South Texas Project Electric Generating Station P.O. Box 289 Wadsworth, Texas 77483

August 19, 2010
U7-C-STP-NRC-100193

South Texas Project
Units 3 and 4
Docket Nos. 52-012 and 52-013
Revised Response to Request for Additional Information

RAI 03.08.04-18, Revision 1, Supplement 1**QUESTION:****Follow-up to Question 03.08.04-2 (RAI 2964)**

FIGURE 9A.4-28 RADWASTE BUILDING, FIRE PROTECTION, SECTIONS A-A AND B-B (SHEET 1)

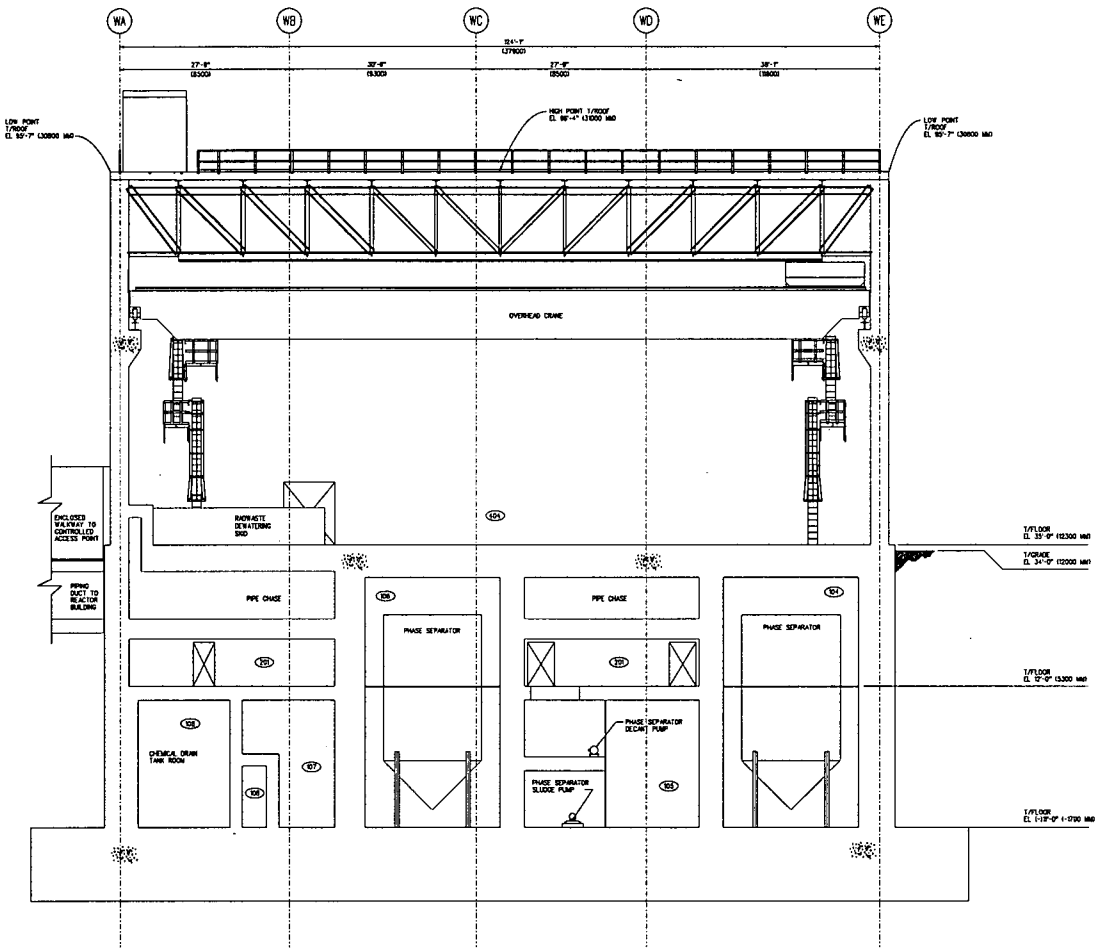
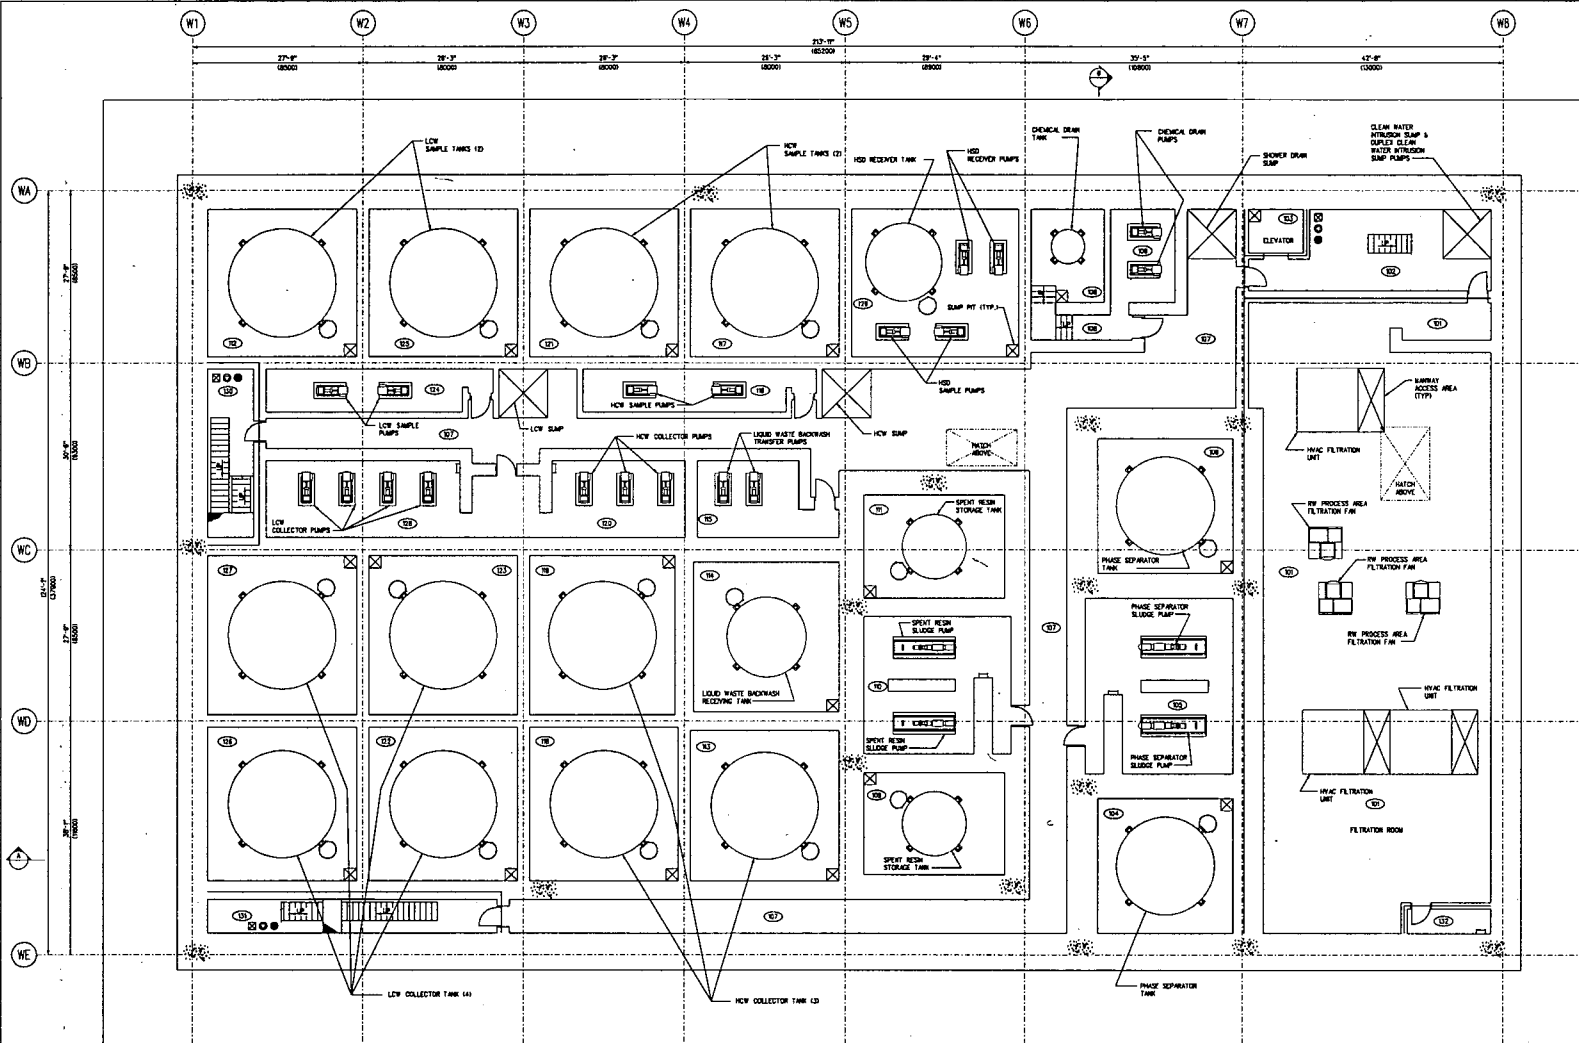
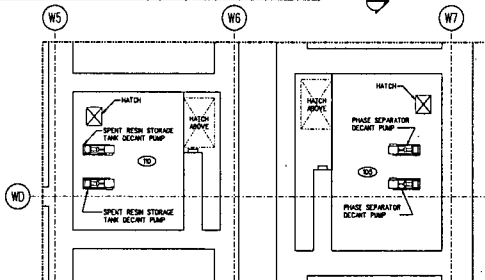
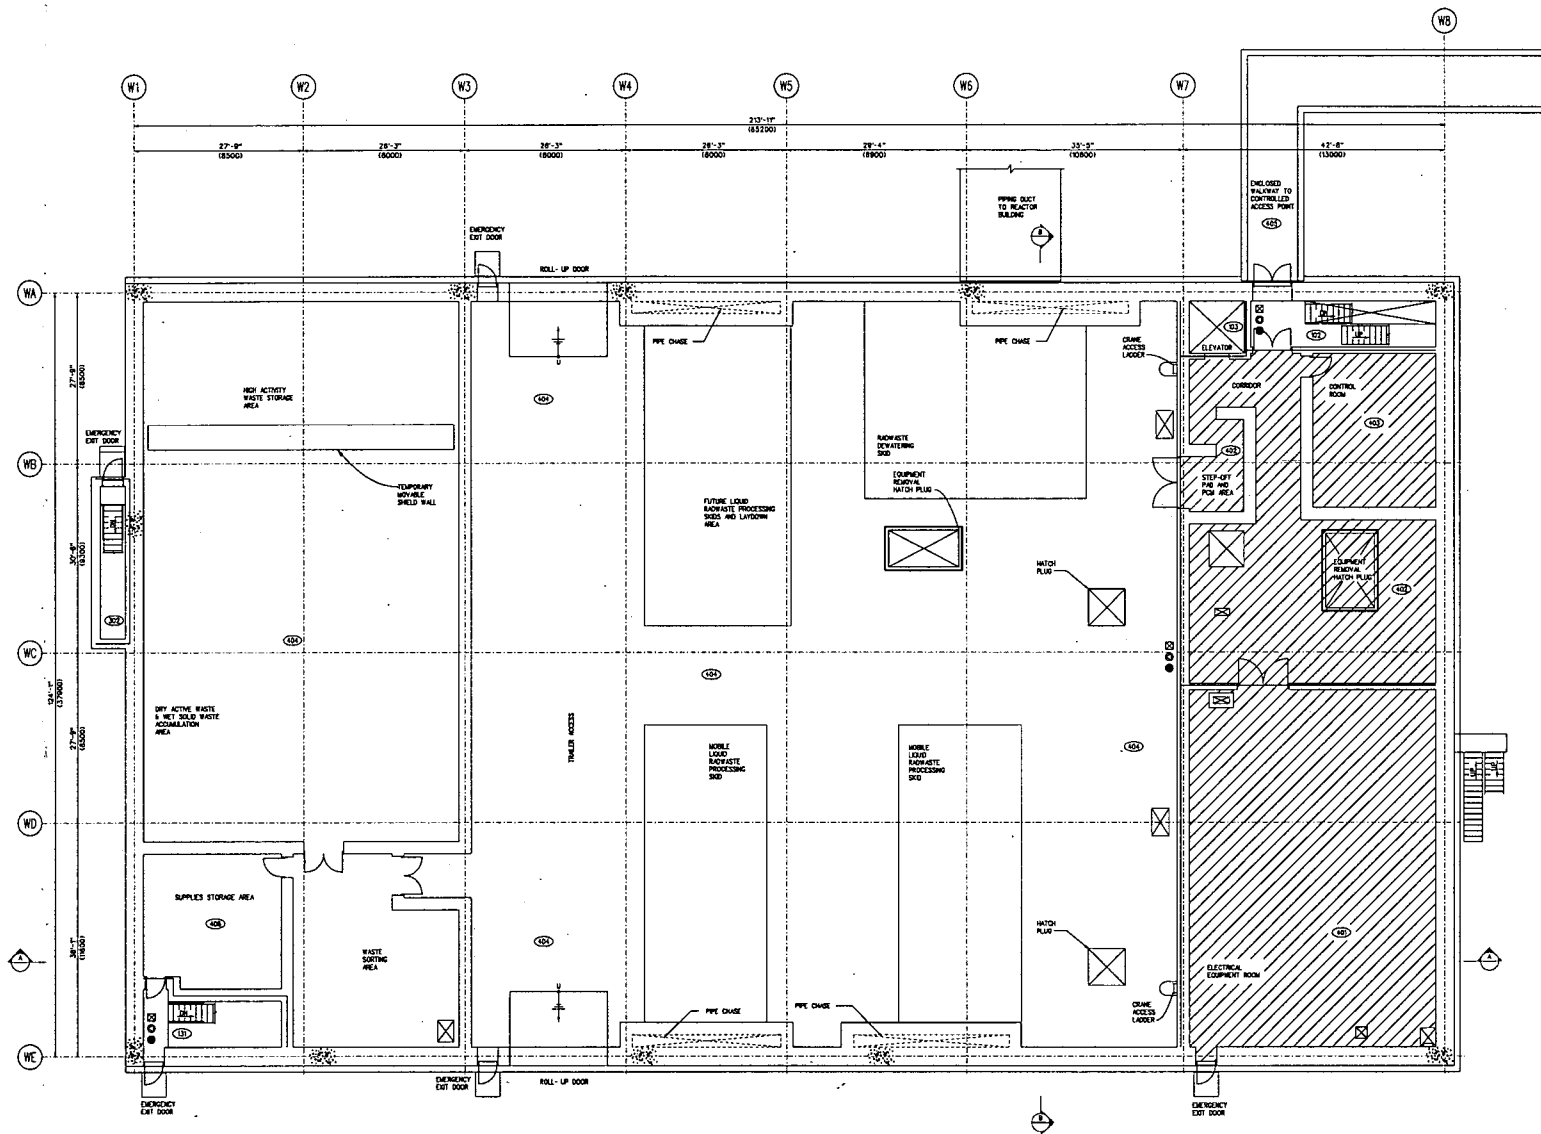
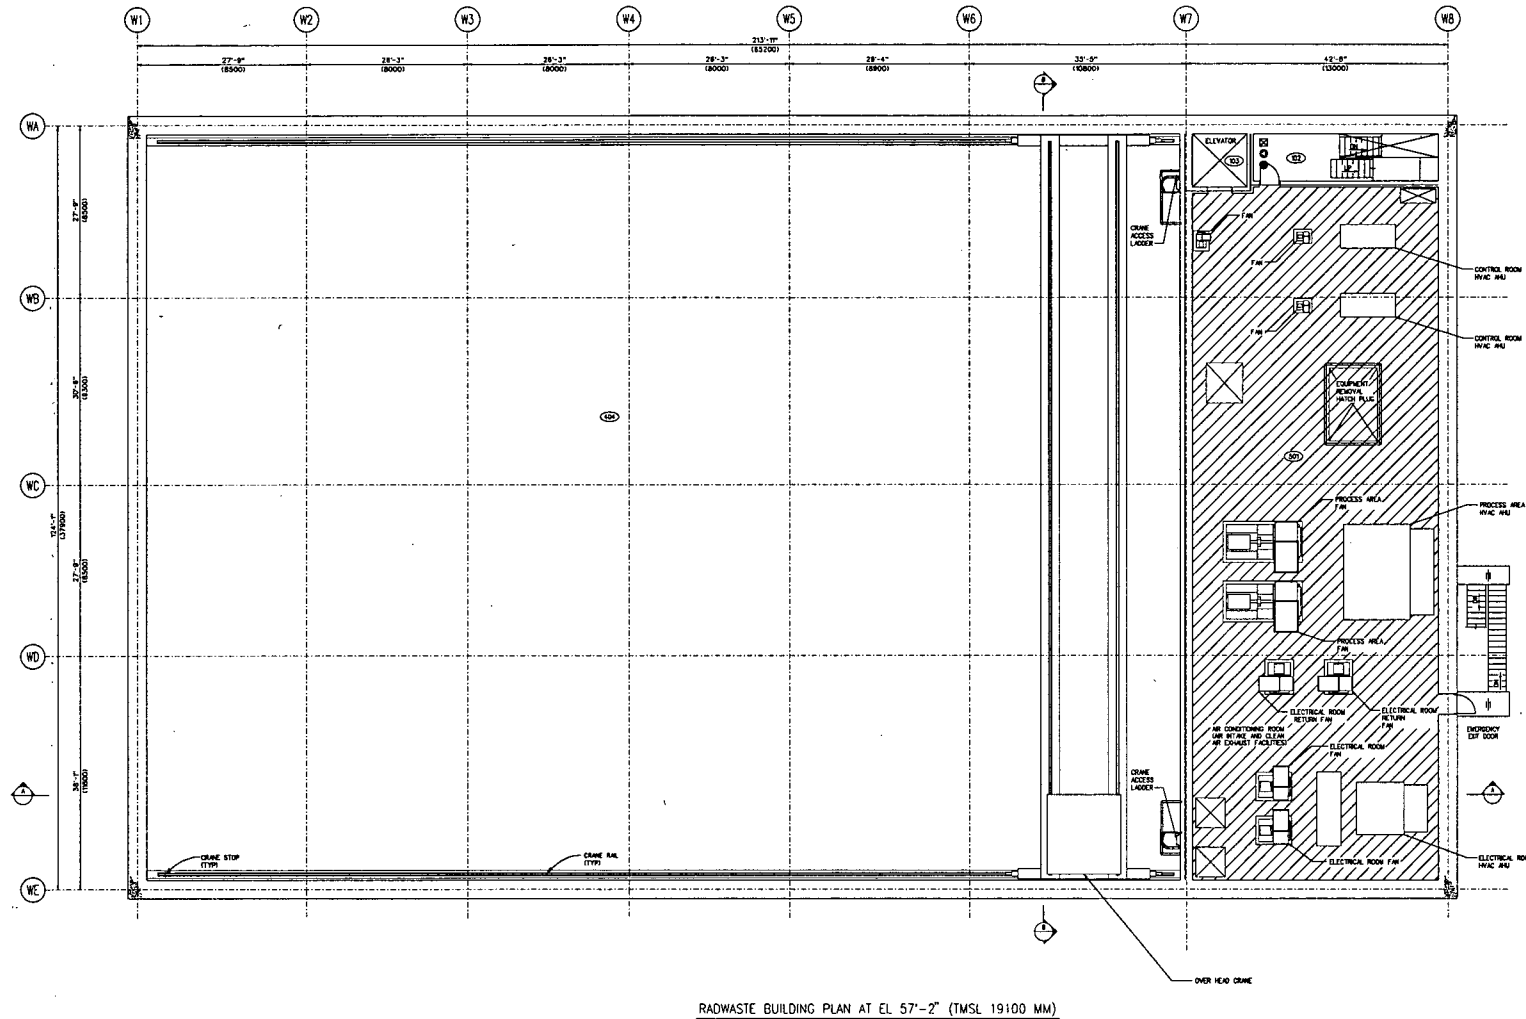
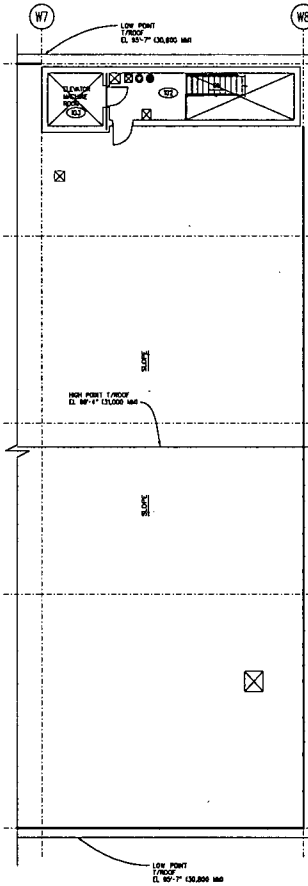
Fire Protection (Figures 9A.4-28 through 9A.4-32)

The Fire Protection figures for the RWB are revised to reflect some changed locations of hose racks, stand pipes, extinguishers, and fire barriers (walls and floors). None of these items is deleted or added. The relocation is due to the interior reconfiguration of the RWB discussed in Attachment 1. There are no functional changes to the RWB fire protection provisions.

Figure 9.4-10 - Radwaste Building HVAC P&ID (Sheet 1 of 3)

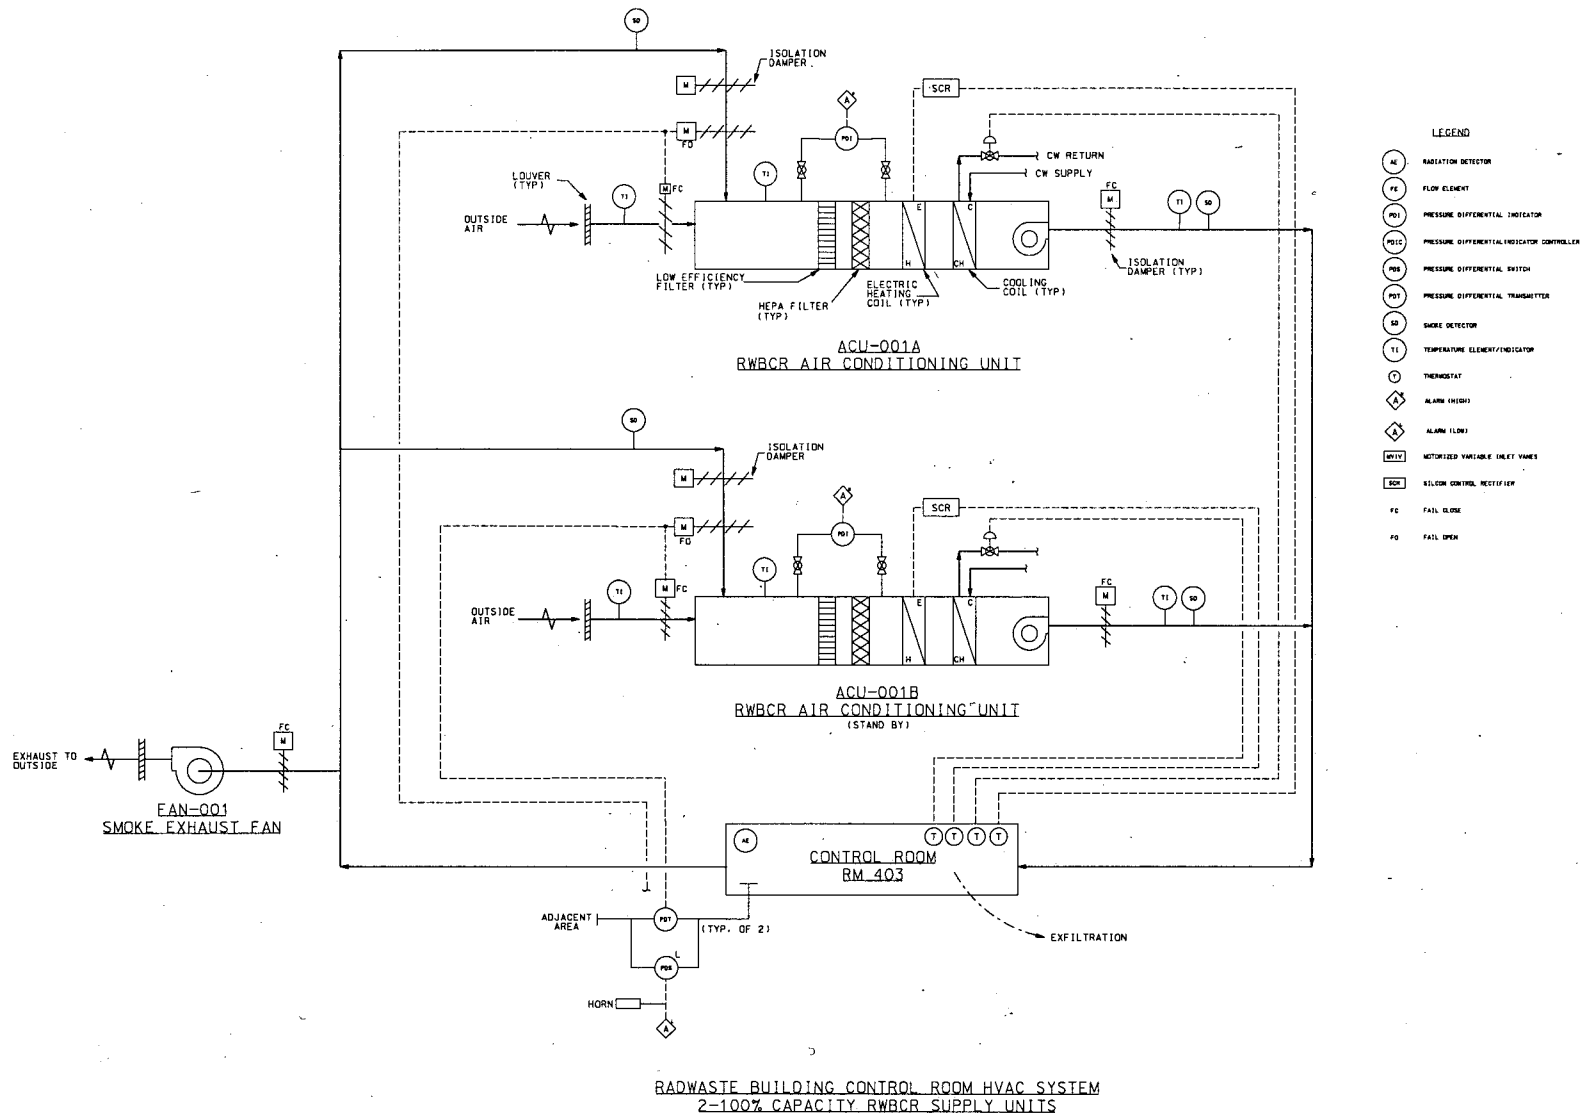
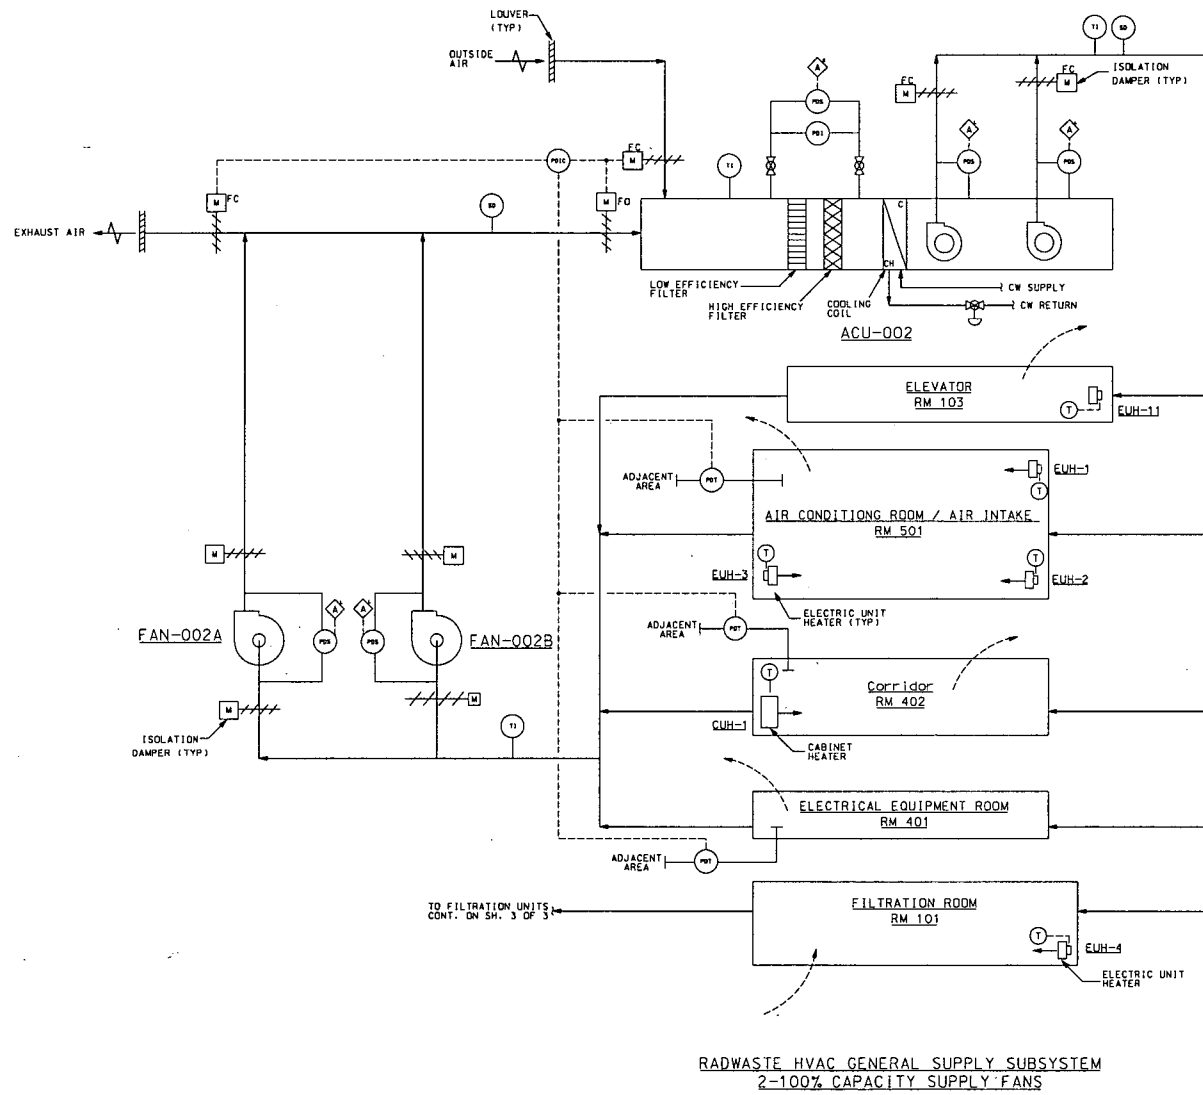
HVAC P&IDs (Figure 9.4-10)

The room numbers and room descriptions for several of the rooms shown on this figure (e.g., Control Room, Electrical Equipment Room, etc.) have been changed to match the room numbers and descriptions shown on the RWB GA figures. These are administrative changes which do not affect the operation or function of the equipment or facility.
